SAFETY RECALL

RZR

Communication #: Z-22-05

SUBJECT: PRIMARY CLUTCH FAILURE PURPOSE

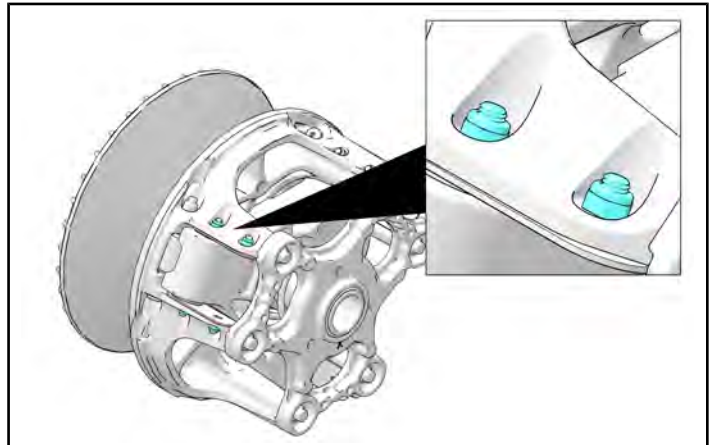
Service parts used in this bulletin look similar, but contain different primary clutch components. Ensure the correct clutch is installed.

Ensure that the correct clutch is installed. Installing the incorrect clutch can result in a vehicle hazard. Review the following images and table to ensure that the correct clutch is installed on the affected vehicle.

MODEL	NEW PART NUMBER (PN)
RZR TURBO S	1327410
RZR TURBO S 4	
RZR XP TURBO	
RZR XP 4 TURBO

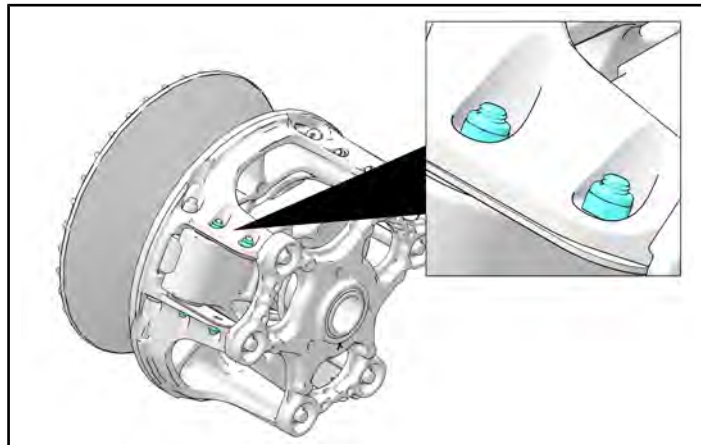
Service parts used in this bulletin look similar, but contain different primary clutch components. Ensure the correct clutch is installed.

Ensure that the correct clutch is installed. Installing the incorrect clutch can result in a vehicle hazard. Review the following images and table to ensure that the correct clutch is installed on the affected vehicle.

MODEL	NEW PART NUMBER (PN)
RZR TURBO S	1327410
RZR TURBO S 4	
RZR XP TURBO	
RZR XP 4 TURBO
